RE: 222 East Fourth Avenue

I reviewed the drawings, and evaluated the site context. My comments on the plans and elevations for this project are as follows:

The purpose of this preliminary design review is to identify issues that are likely to arise as the project proceeds to Planning Commission review in order for the applicant to anticipate and respond to the concerns prior to submitting a formal application.

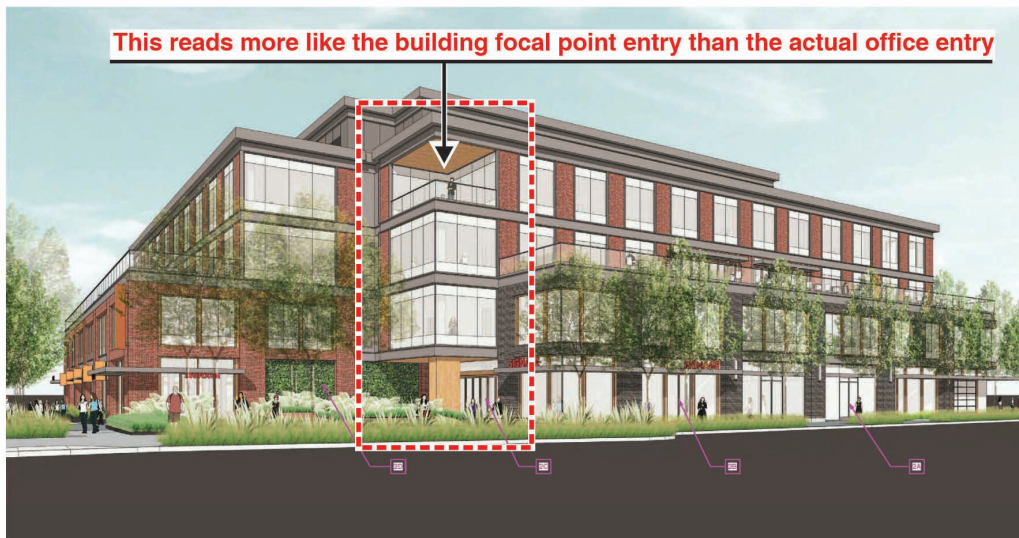
1. The entry lobbies to the offices and to the residential units are poorly defined.

**Residential entry
is very weak**

This reads more like the building focal point entry than the actual office entry

- The massing and design of the East Fourth Avenue base facade is not very sympathetic to the commercial frontages across East Fourth Avenue and in the adjacent downtown area along East Fourth Avenue and B Street. The uniformity of the storefronts as just similar openings in the brick wall is very much out of character with the uniqueness of the building's immediate context.

**This retail frontage is not very sympathetic to the
commercial frontages across 4th Avenue**

***Fabric awnings are noted
but not visually apparent***

3. The overall building massing and facade/height articulation is not very sympathetic to the adjacent downtown area.

These strong unbroken linear and rectangular forms are in great contrast to the current Downtown character

4. The massing, design, architectural details and landscaping of the East Fifth Avenue facade is not very sympathetic to the multifamily residential frontage across East Fifth Avenue.

This streetscape and facade is not very sympathetic to the multifamily residential frontage across 5th Avenue

5. The two-story brick building base is divided into two different colors - red brick along East Fourth Avenue and B Street and dark gray brick along East Fifth Avenue and Ellsworth Avenue. This division between strong retail frontages and other frontages may work, but may need some further explanation and discussion.

Red brick base on retail streets and gray brick on other two facades may work, but intent is not totally clear

6. The building corner at the East Fourth Avenue and B Street commercial corridors intersection is quite strong on the existing building and greatly down played on the proposed design.

This corner is much weaker than the current building

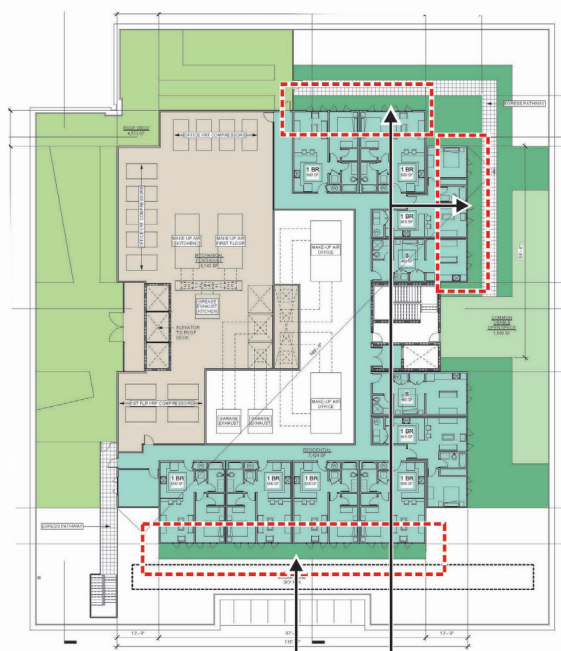
7. Overall, the facades of the building masses are very flat, in contrast to the depth and articulation of the current building on the site. While windows in the two-story building base have some recess, upper floor windows have very little.

Facades without significant window recesses seems very flat

Blade signage doesn't look very workable given pedestrian visual blockage by projecting canopies

8. Blade signage at the pedestrian level is an appropriate approach in this context, but the vertical format may not be workable as shown, given the potential visual blockage from sidewalk level by the projecting canopies.
9. Fabric awnings are noted along the retail frontages, but are not apparent in the sketches.
10. The residential massing and facades on the top floor currently have no distinctive character or quality.
11. The absence/extent of the private open space for the residential units seems quite limited given the large amount of roof area available.

Extent of private outdoor space for these units seems quite limited given the large amount of roof area available
